Direction de la sûreté
des installations
nucléaires

DSIN-FAR/SD6/N° 01-60 119

Following a DSIN's request, the Institute for Nuclear Safety and Protection has initiated a comparative technical evaluation of several advanced nuclear power plant projects with the objective to notably identify relevant advantages with regard to safety.

ANNEX

Question 9.8

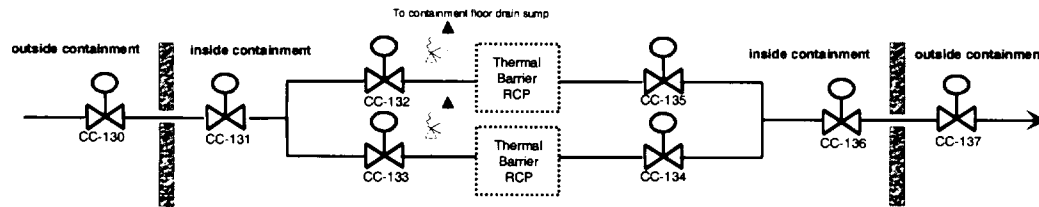
How is detected a leakage outside the containment from the three non-return valves in the direct vessel injection line? From which limit is the inverse flow rate identified?
